P.O.A.D.P. PLAN
for
VALLEY-HI 14

Re: Valley Hi 14

POADP # 651

The City Staff Development Review Committee has reviewed Valley Hi 14 Preliminary Overall Area Development Plan # 651. Please find enclosed a signed copy for your files. Although your plan was accepted, please note the following:

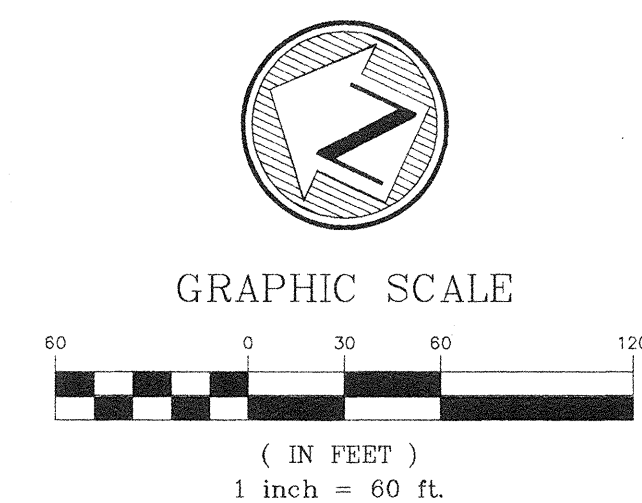
- Based on the topography, a Flood Plain Study and drainage review will probably be required during the platting process.
- In consideration of public safety and convenience, excessive grades by reason of topography should be avoided in street layouts and arrangements.
- Access and R.O.W. issues along State facilities will need to be resolved with the Texas Department of Transportation (TXDOT). For information about these requirements you can contact TXDOT at 615-5814.
- This development will need to comply with tree preservation ordinance #85262. For information about these requirements you can contact Building Inspections at 207-7102.
- It will be expected that you will plat all of the property depicted in your POADP, to include: floodpains, drainage areas and open space.
- I would encourage you to work closely with the school district, so that they can plan accordingly.

Comments: Drainage easements will be require
and will be address during the platting
process.
